**GENOA CHARTER TOWNSHIP
PLANNING COMMISSION
PUBLIC HEARING
JULY 22, 2013
6:30 P.M.
AGENDA**

OPEN PUBLIC HEARING #1... Review of site plan, special use, and environmental impact assessment for proposed 16,120 square-foot gymnasium and classroom addition for Brighton Nazarene Church, located at 7669 Brighton Road in Section 25, petitioned by Brighton Nazarene Church.

Attention:	Kelly Van Marter, AICP Assistant Township Manager and Planning Director
Subject:	Brighton Nazarene – Special Land Use and Site Plan Review #2
Location:	7669 Brighton Road – northwest corner of Brighton and Aljoann Roads
Zoning:	SR Suburban Residential District

**Re: Brighton Nazarene Church Facility Expansion
Site Plan Review Resubmittal #1**

DESIGNED BY: ST
DRAWN BY: AEB
CHECKED BY:
SCALE 1" = 50'
JOB NO. 13-100
DATE 5-31-13
SHEET NO. 5

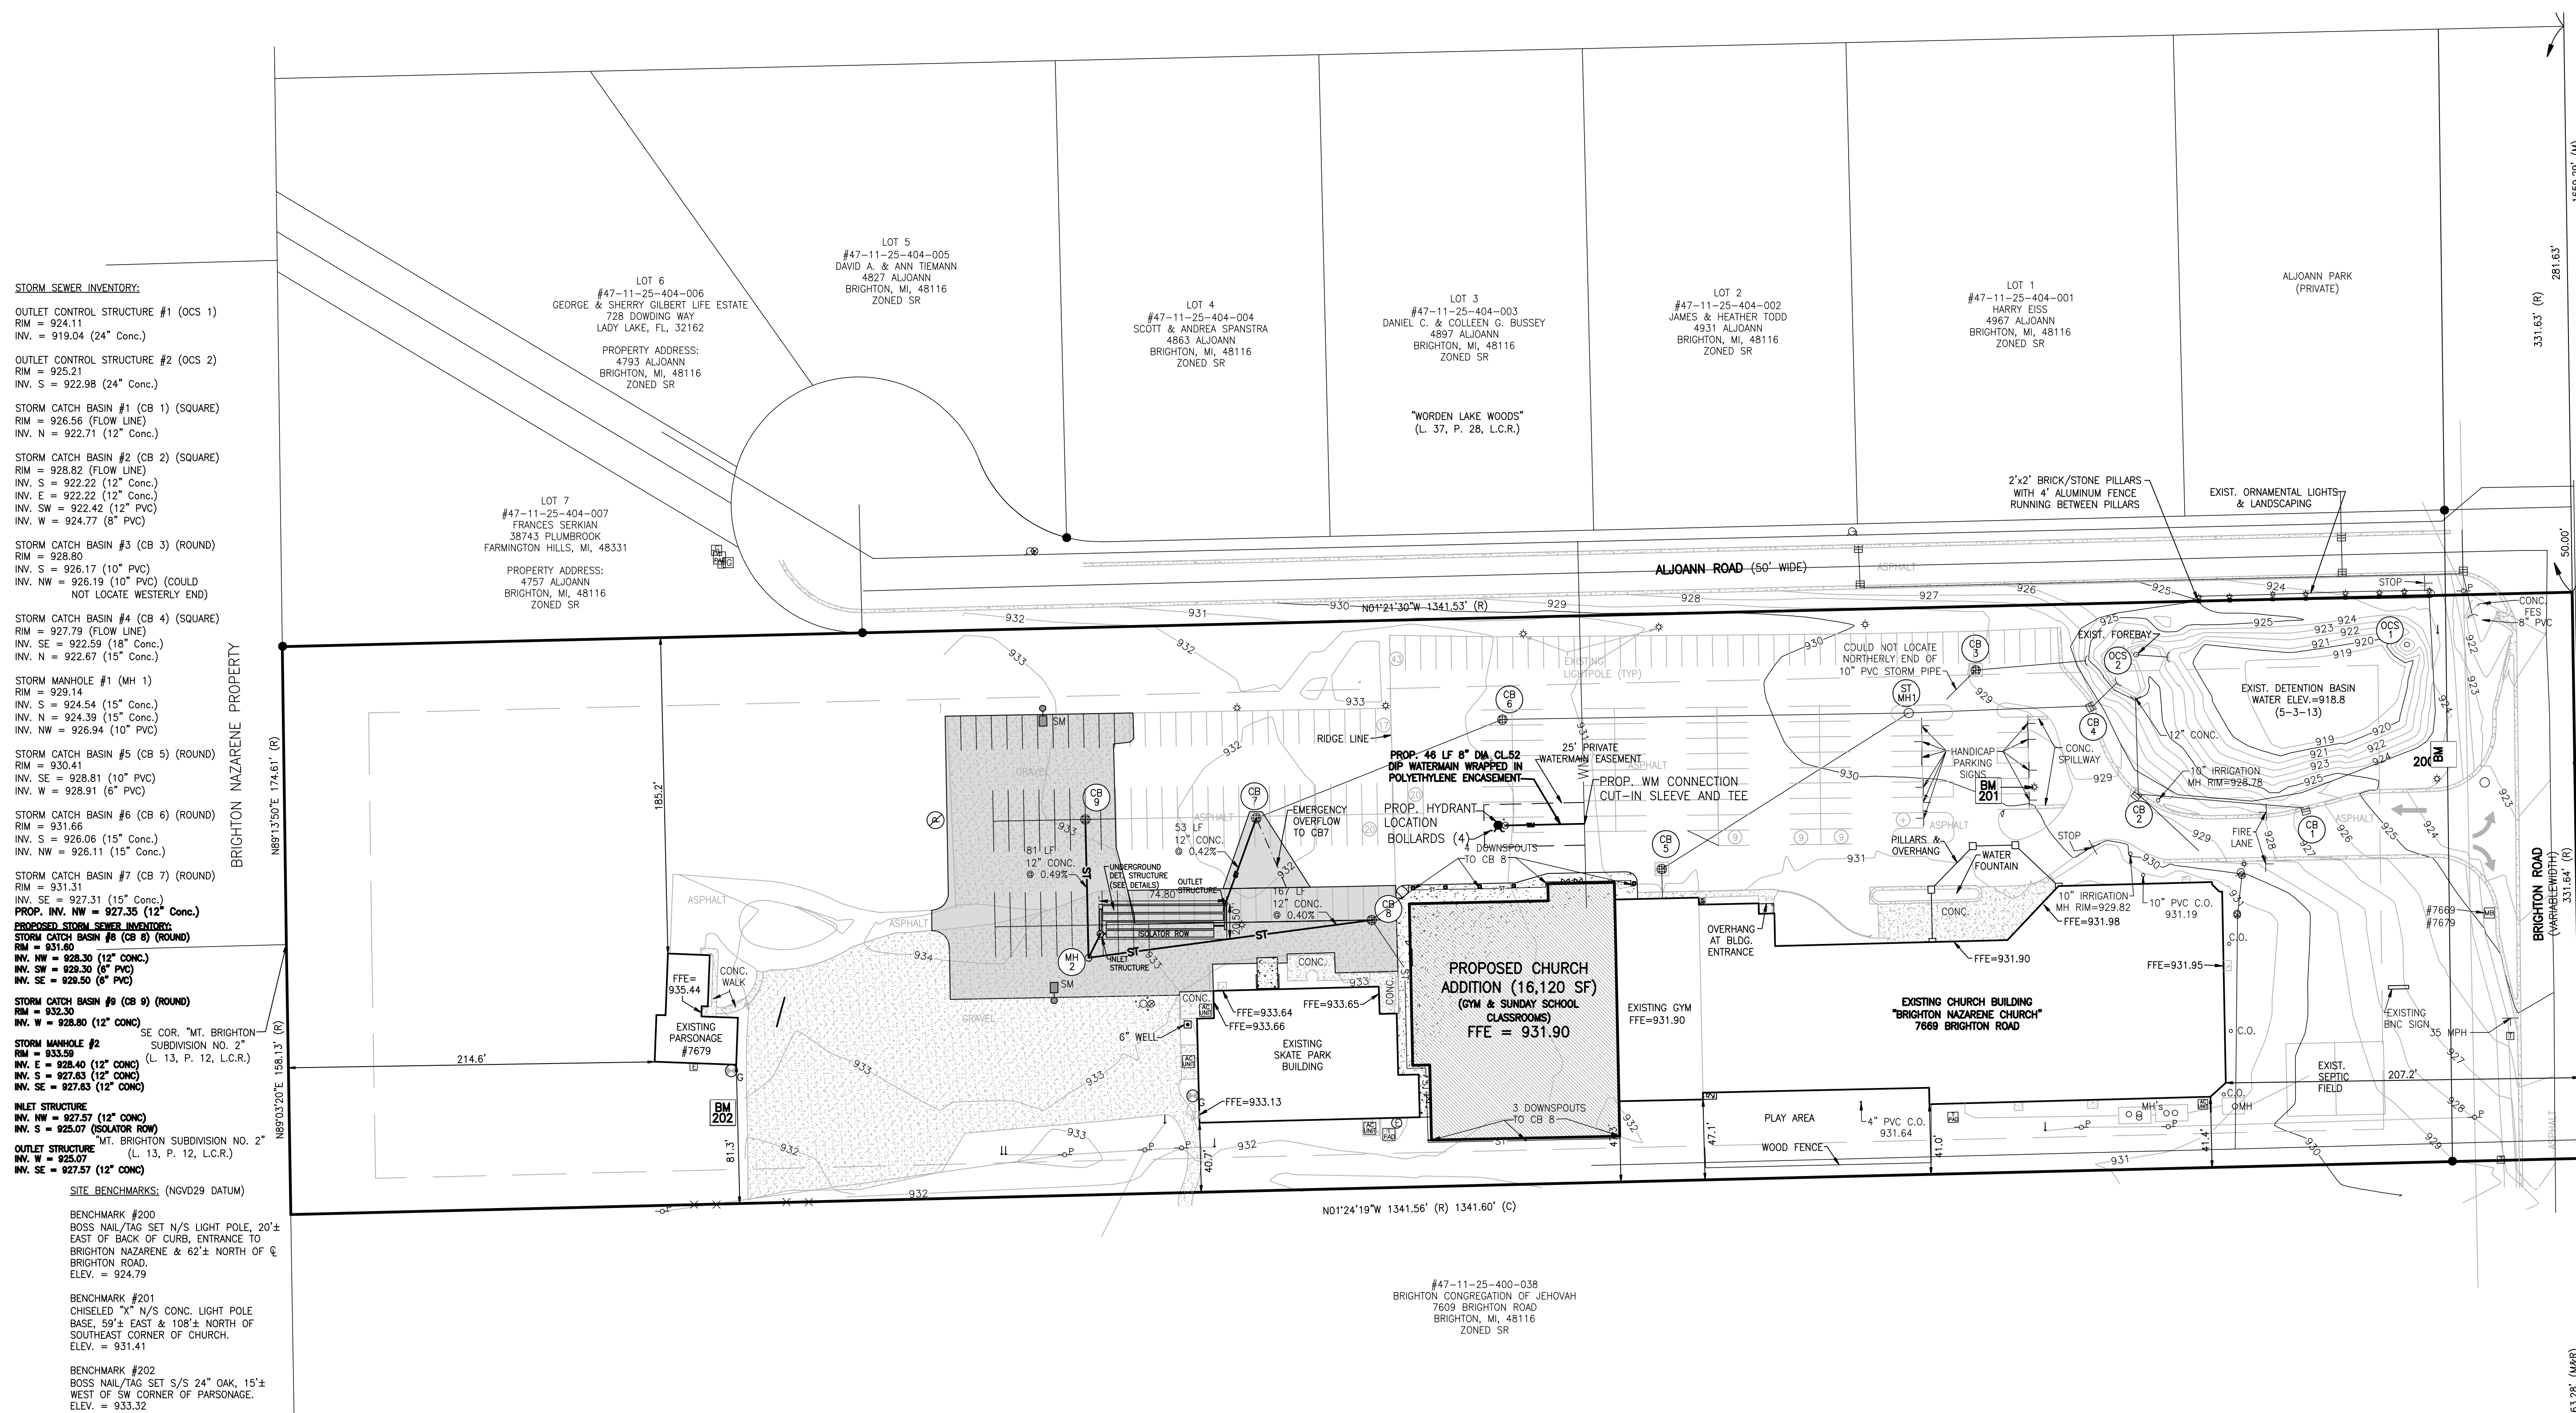
1. The existing water main on the site has been changed with the fire hydrant that currently services the north end of the site now shown connected to the existing water main in Aljoann Road. An additional fire hydrant near the bend adjacent to the west property line is recommended to provide fire protection coverage to the western side of the site.

3. The location of any new water service connections should be clearly shown on the drawing. If any existing water service connections are presently located on a portion of water main to be removed, a replacement plan must be included in the final construction drawings.

4. Plans show a 6" well on the site, just north of the skate park building, less than 15 feet from the proposed water main trench. Please clarify the type of well and any impact on the water main alignment, proposed service connections, or if abandoned.

LANDSCAPE & LIGHTING PLAN

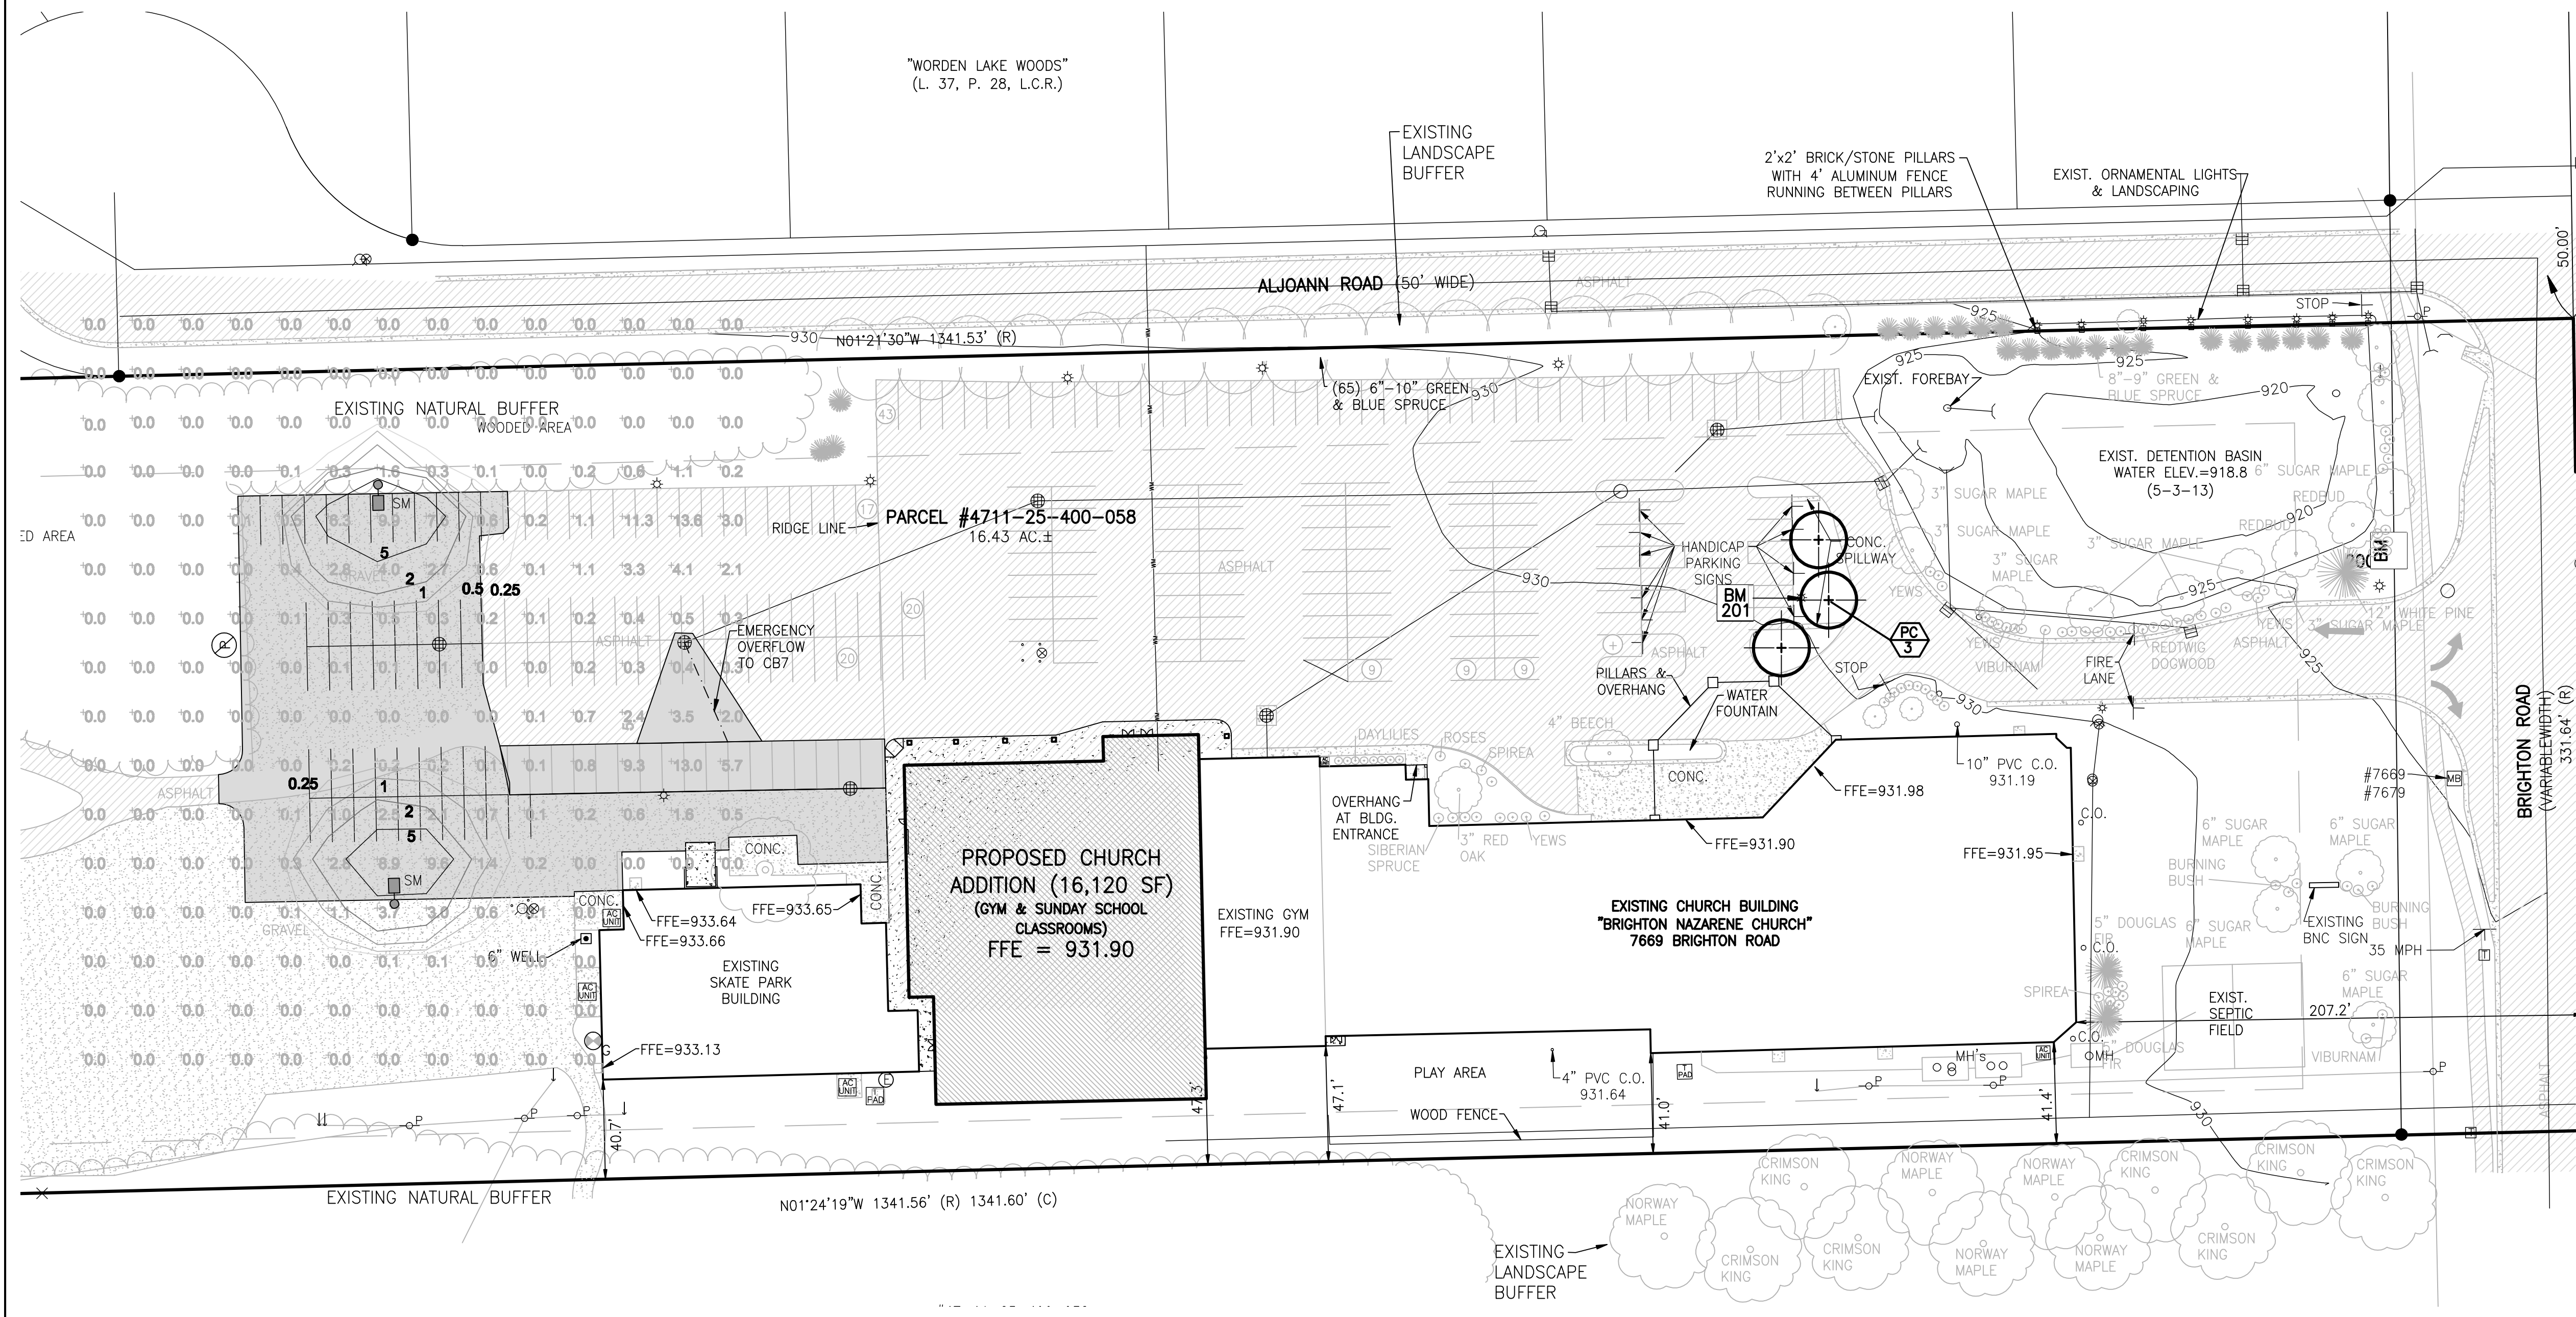
The proposed plan includes 3 new canopy trees in a parking lot island towards the south end of the site. While much of the parking lot exists today, the Township may wish to require additional parking lot landscaping in accordance with Section 12.02.04 to break up the large expanses of pavement, particularly for the new paved parking area.

The site plan also identifies several existing light fixtures, but does not include any details. The Township may wish to request details and an expanded photometric plan to ensure that existing lighting complies with current requirements.

FRONT (EAST) ELEVATION
SCALE: 1/8"=1'-0"

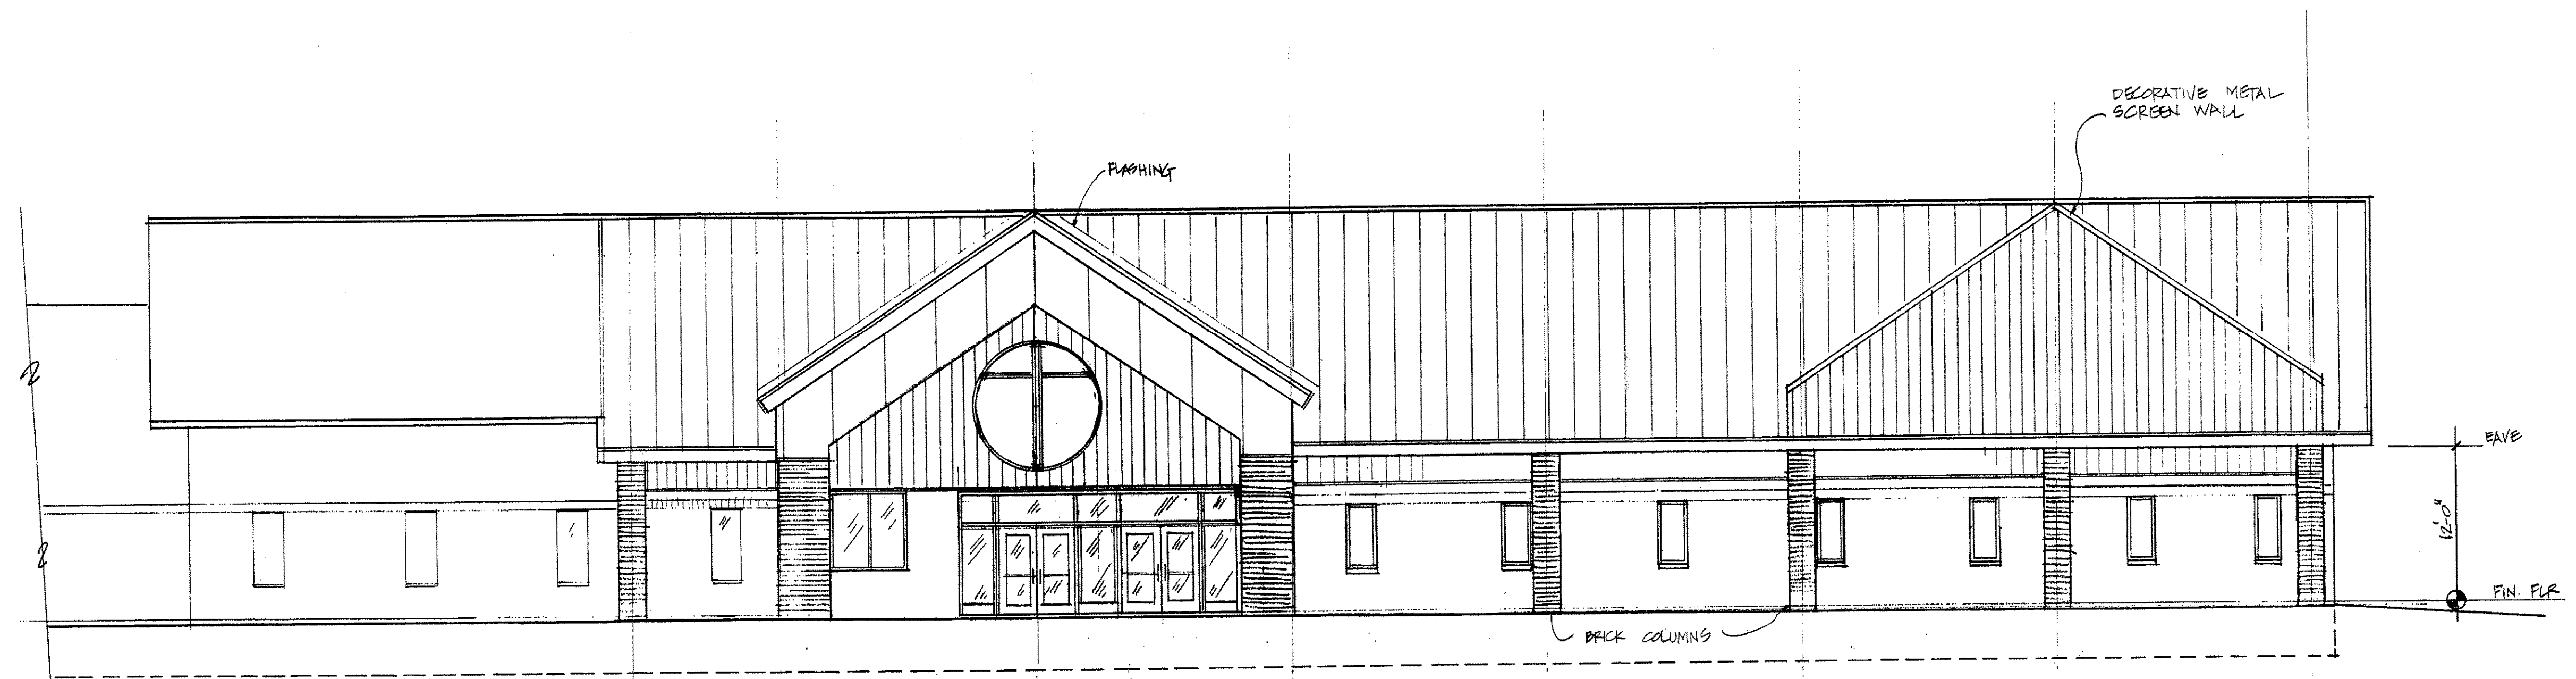
The elevation drawings submitted provide a building height of approximately 23 feet for the proposed addition; Section 3.04 establishes a maximum building height of 35 feet.

- 2. Building Materials and Design.** Proposed elevations, including colors and materials, are subject to review and approval by the Planning Commission. The submittal includes elevation views of two of the three building sides and generally utilizes a brick veneer and metal siding as primary materials. The east elevation includes brick columns matching those at the main church entrance. The addition also includes a pitched metal roof.
